RE: Inspection Letter – 2607 SW Tracker Ln, Lee’s Summit, MO (Lot 132 Hook Farms)

Vista Structural Engineering, LLC was asked to address the following rough-in inspection items for the project located at above referenced address. Please see the following responses with attached site photos for reference.

PHOTO #1 - WALL DOUBLE TOP PLATE PENETRATION

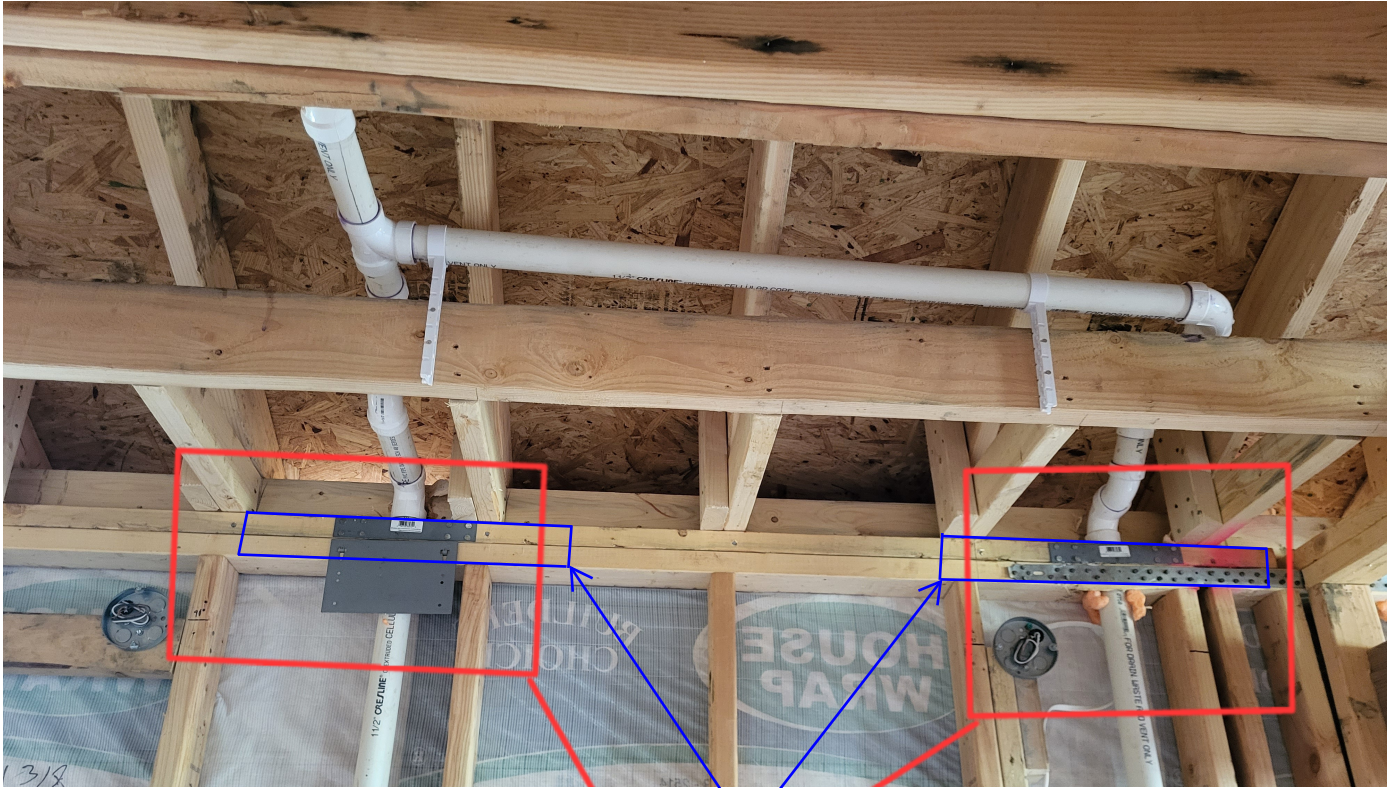
1) **Inspection comment:** “Address master vanity penetrations”

Vista Structural’s response: GC to install MSTC40 strap at ea. wall double top plate penetration (RE: Photo 1). Wall stud penetration is acceptable due to stud shoe connectors provided by contractor (RE: Photo 2).

INSTALL SIMPSON MSTC40
@ EA. DOUBLE TOP PLATE
NOTCH. FASTEN w/ (28)
0.148 X 3 1/4" NAILS TOTAL.
